City of El Paso – City Plan Commission Staff Report

2nd Revision

Case No:	SUSU14-00009 Country Club Place Southside Replat A
Application Type:	Resubdivision Combination
CPC Hearing Date:	March 13, 2014
Staff Planner:	Alfredo Austin, 915-212-1604, *austinaj@elpasotexas.gov*
Location:	West of Riverbend and South of Sunset
Acreage:	1.17 acres
Rep District:	8
Existing Use:	Residential/Single family
Existing Zoning:	R-1 SP (Residential/Special Permit)
Proposed Zoning:	R-1 SP (Residential/Special Permit)
Nearest School:	Zach White Elementary (1.61 mile)
Nearest Park:	Charyl Ann Duck Pond (1.07 miles)
Park Fees:	~~$2,740~~ As per section 19.20.060(I) this subdivision is excluded from parkland dedication calculation.
Impact Fee Area:	Not in Impact Fee Area
Property Owner:	L W Sunset Properties, LLC
Applicant:	L W Sunset Properties, LLC
Representative:	Roe Engineering

ATTACHMENT 3

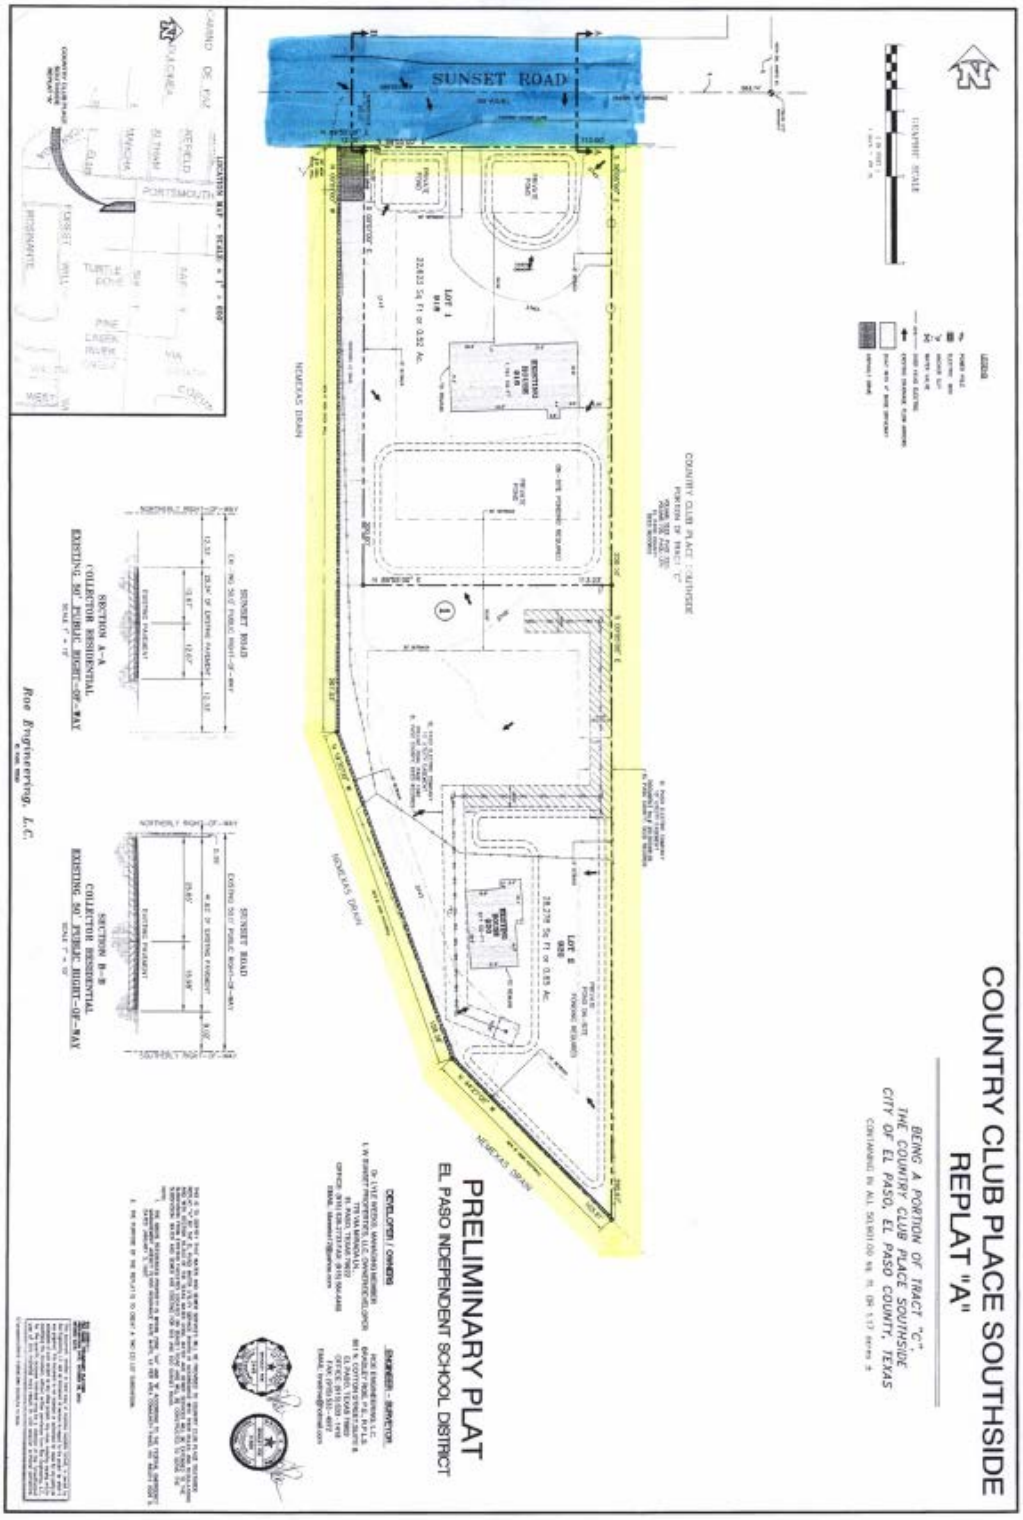
1. Mutual drainage and maintenance agreement between lots 1 and 2 for drainage into private pond in lot 1.
2. Provide sidewalk on Sunset Road typical cross section.
3. Storm-water management inspection and maintenance agreements for private facilities is required between lots 1 and 2 per code 19.19.040.
4. Applicant shall comply with FEMA requirements.

ATTACHMENT 4

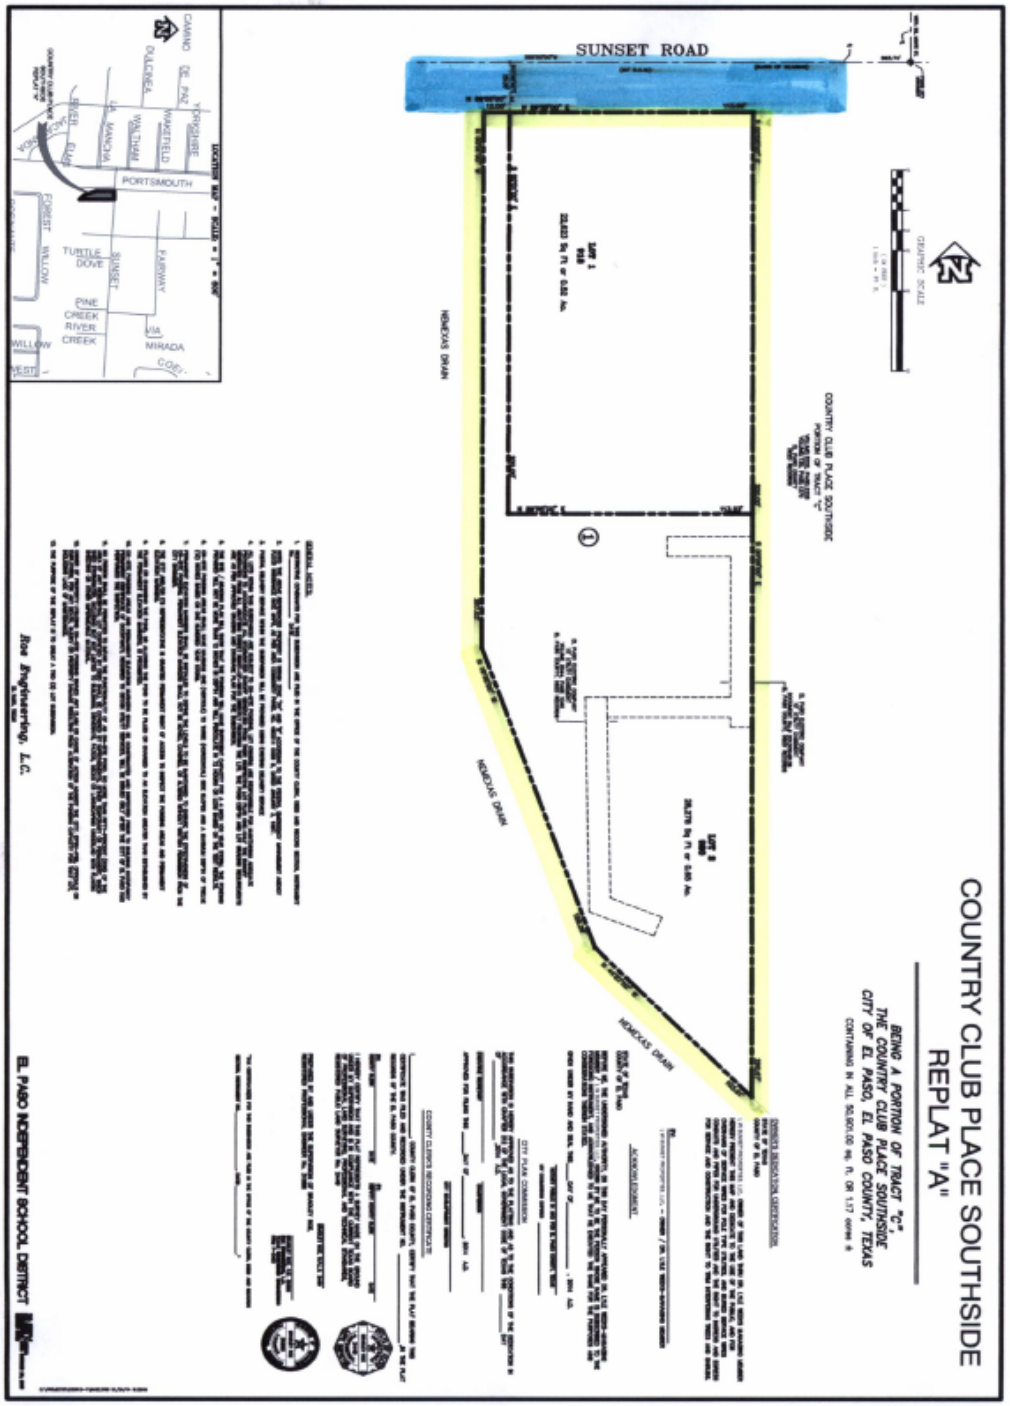
served by such panhandle will be required by the fire marshall to be sprinklered and have a hard wired alarm system. A note shall be added to the recording plat and the subdivision improvement plans indicating whether buildings are required to be sprinklered within the subdivision, and which lot numbers have such requirement.
